CERTIFICATE OF APPROPRIATENESS

Property: 614 W. Main Street, Tract 6 & 7, Block 8, Lockhart Connor & Barziza Subdivision. The property includes a historic 1,887 square foot one-story wood frame single family residence situated on a 5,000 square foot interior lot.

Proposal: Alteration – Install replacement skirting along the perimeter of the existing structure on the front and side elevations.

PREVIOUS PRESSED METAL SKIRTING
(REMOVAL APPROVED APRIL 2012)

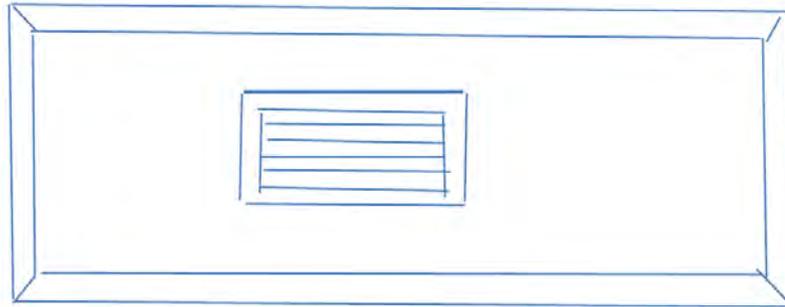
Many of the exterior elements of this structure have since been removed, including the original siding and skirting. However, skirting design on similar houses, found within this and other districts, indicate that due to the tall foundation and finished floor height, as well as the visual prominence of the foundation, it is likely that the skirting on this structure was substantial. Simple cementitious panels would be appropriate to screen the open space under the foundation but is not appropriate skirting to cover the framing itself.

The proposed skirting is not compatible with the material and character of the property. Flat 40" tall panels installed around the perimeter of the structure are out of scale and not compatible with the character of this house and for and are not typical within the district. A horizontal lap siding skirt would be more characteristic for this style of house.

The applicant received a COA for a similar scope of work in April 2012. At that time, staff misunderstood the proportions of the proposed panels. Staff is not opposed to the use of shorter panels meant to screen the open area under the foundation in order to prevent access to small animals. Rather, staff's objection to the proposal is that the proposed panels are 40" tall and will partially screen the framing itself, which should more appropriately be covered by horizontal lap siding.
